DEPARTMENT OF TRANSPORTATION**National Highway Traffic Safety Administration****49 CFR Part 572**

Anthropomorphic Test Devices; Six-Year-Old Crash Test Dummy

ACTION: Final rule; response to petitions for reconsideration.

Figure N 2

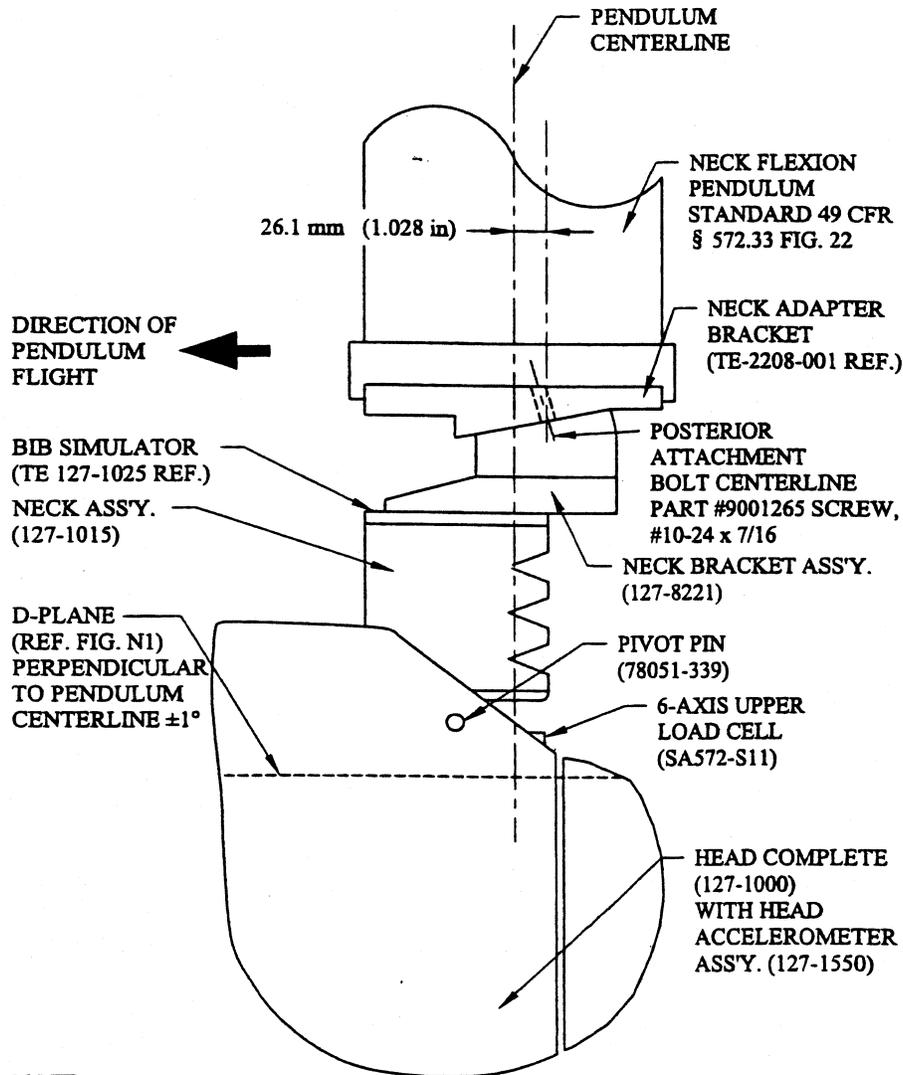
- Figure N2: (1) Relocate the 26.1 mm reference to the centerline of the posterior attachment bolt to reflect dimensional proportionality; (2) change reference from "Neck Flexion Pendulum 46 CFR 572.33 FIG 22" to "Neck Flexion Pendulum 49 CFR 572.33 FIG 22"; and (3) add part number for bolt "#9001265 Screw, SHCS #10-24 x 7/16".

Figure N 3

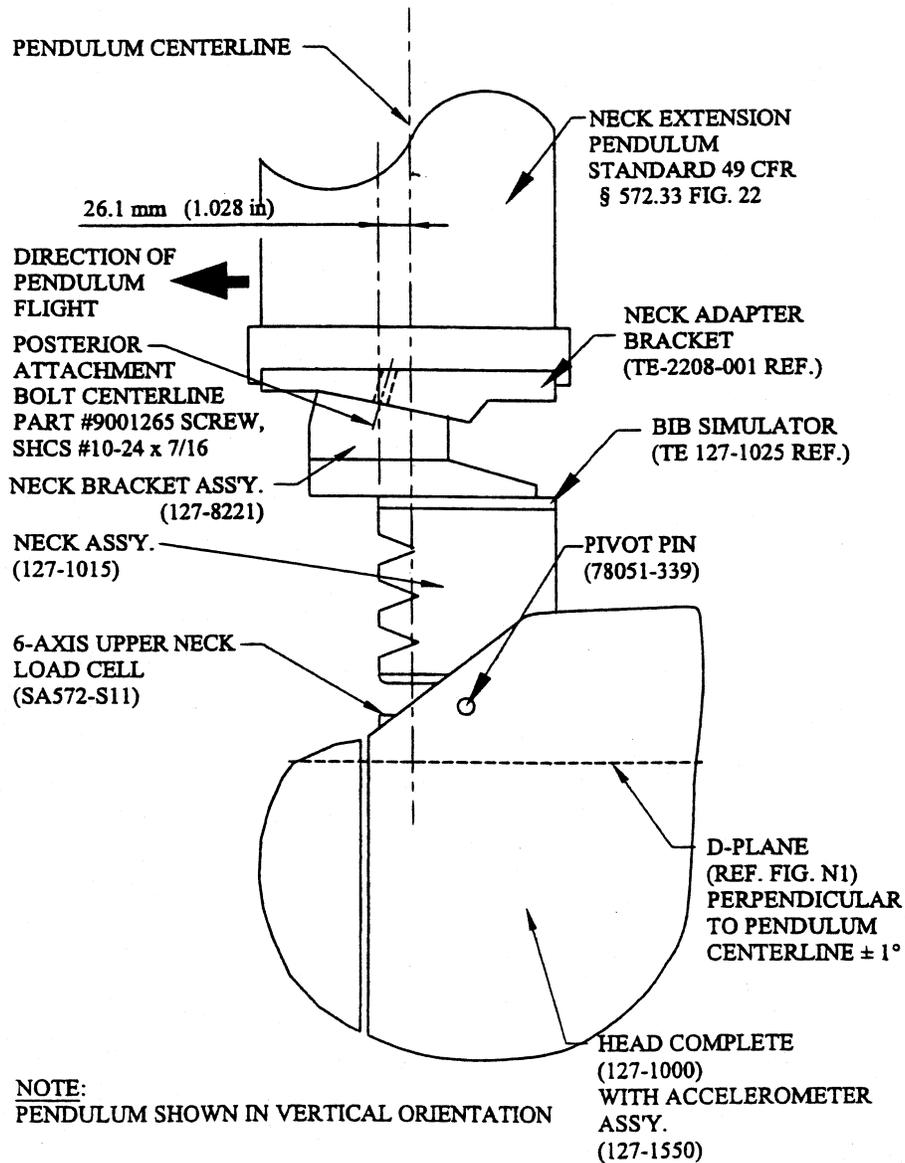
- Figure N3: (1) relocate the 26.1 mm reference to the centerline of the posterior attachment bolt to reflect dimensional proportionality; and (2) add part number for bolt "#9001265 Screw, SHCS #10-24 x 7/16".

FIGURE N 6
KNEE IMPACT TEST SET-UP SPECIFICATIONS

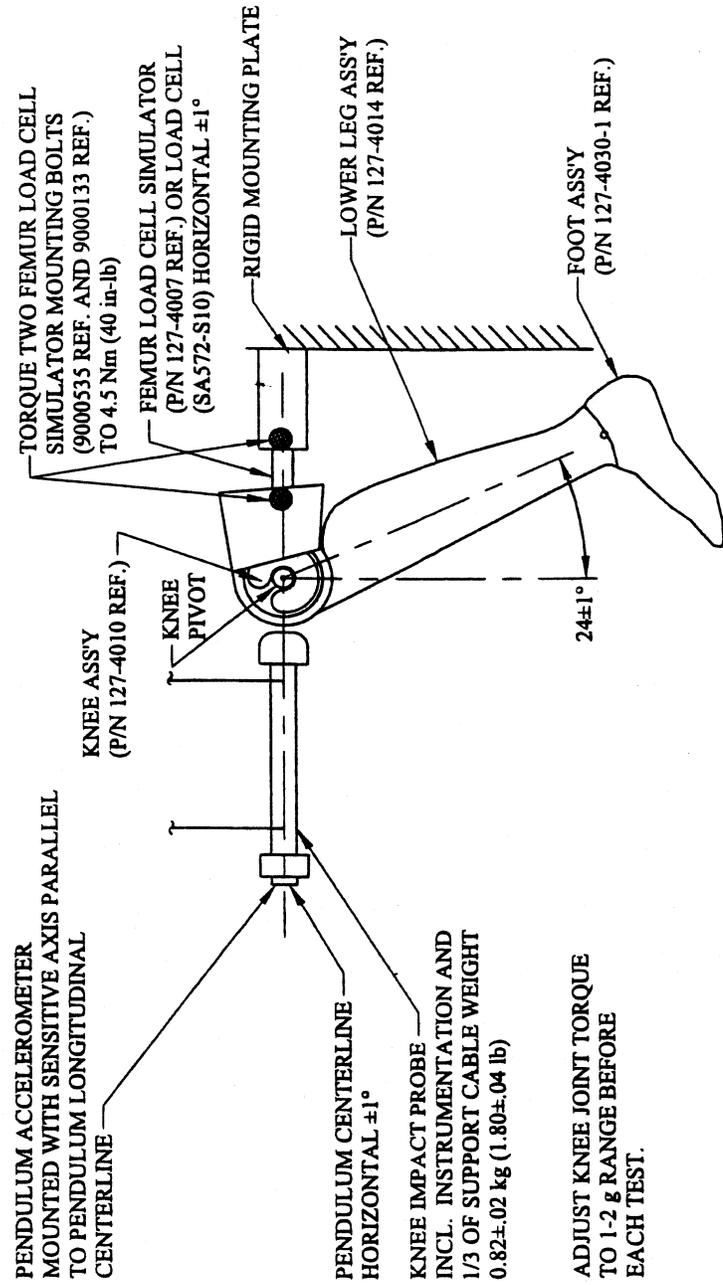
- Figure N6: (1) remove note SA572-S4; and (2) change the weight tolerance on the knee probe from "0.82 ± 0.01 kg (1.80 ± .02 lb)" to "0.82 ± 0.02 kg (1.80 ± .05 lb)".
